CABINET MEMBER FOR ENVIRONMENT – 8 FEBRUARY 2018
BICESTER/ AMBROSDEN - PROPOSED 40MPH SPEED LIMIT IN
VICINITY OF THE A41 RODNEY HOUSE / GRAVEN HILL
ROUNDAABOUT

Report by Director for Infrastructure Delivery

PROPOSED 40MPH SPEED LIMIT: A41 RODNEY HOUSE RBT OXFORDSHIRE COUNTY COUNCIL - HIGHWAYS & TRANSPORT

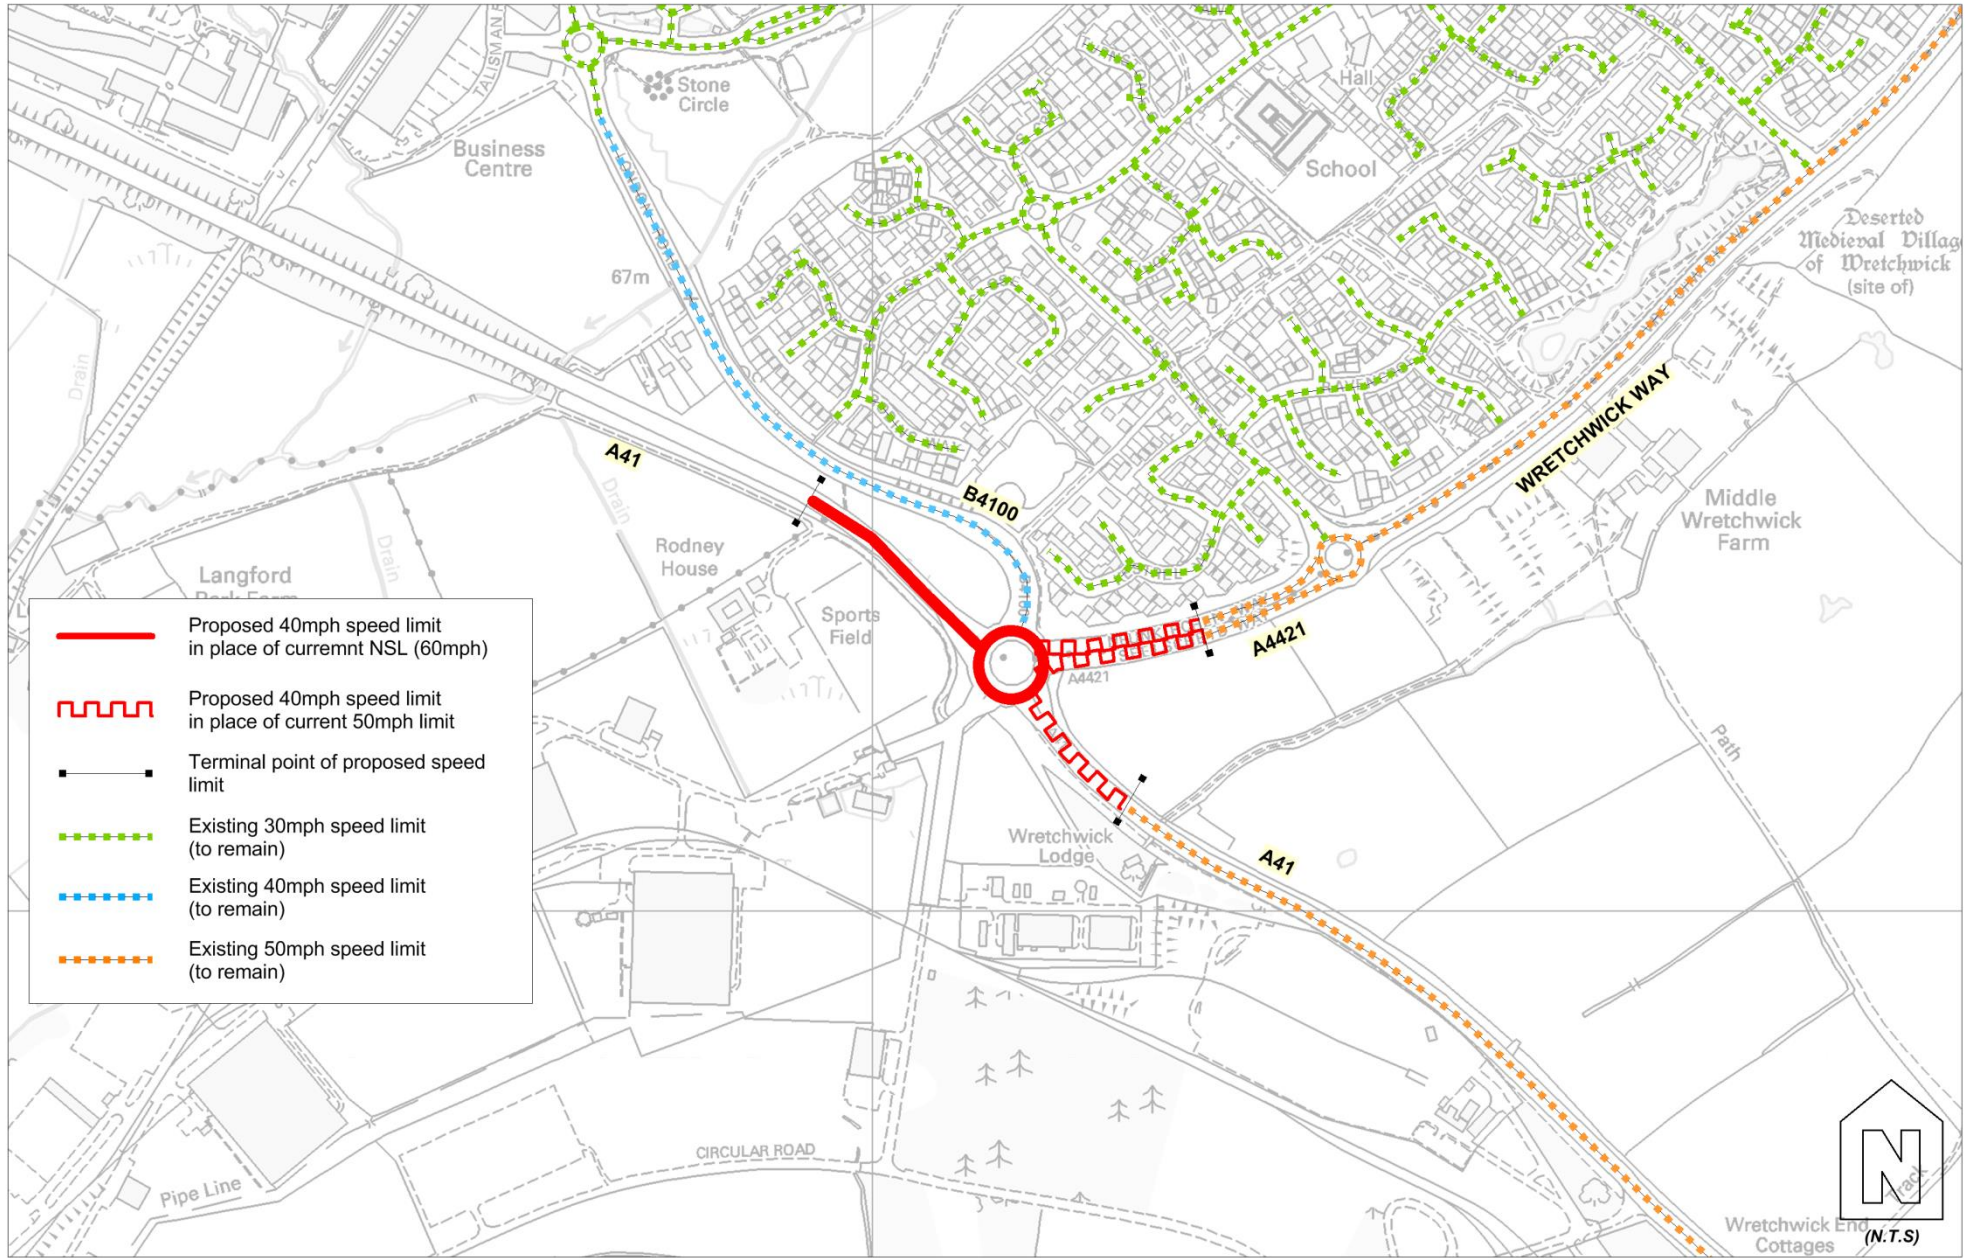
RESPONDENT	SUMMARISED COMMENTS
(1) Traffic Management Officer, (Thames Valley Police)	No objection.
(2) Local County Councillor (Otmoor Division)	Object - As County and District Councillor for this area I do not believe that a reduction in the speed limit is necessary along these stretches of road. Given my experience of the A41 between the Esso Roundabout and the Vendee Drive Roundabout where a similar speed limit has been introduced a similar limit here is not necessary and would not make the stretch of road any safer than it currently is.

6. While the objection of the local member is noted, it should be stressed that the need for a lower limit has been identified as part of a technical safety assessment of the specific junction layout.
7. The limited extent of the proposal will ensure that additional journey times for traffic as a consequence of the lower limit will be minimal.
8. The comment that a 40mph speed limit is not required on the A41 immediately south of Bicester is also noted. It is though considered that the frequent junctions to accommodate traffic movements in this area of rapid commercial and residential development do point to the limit being required for safety reasons, with the additional benefit of lower levels of noise for the occupants of nearby houses and other premises.
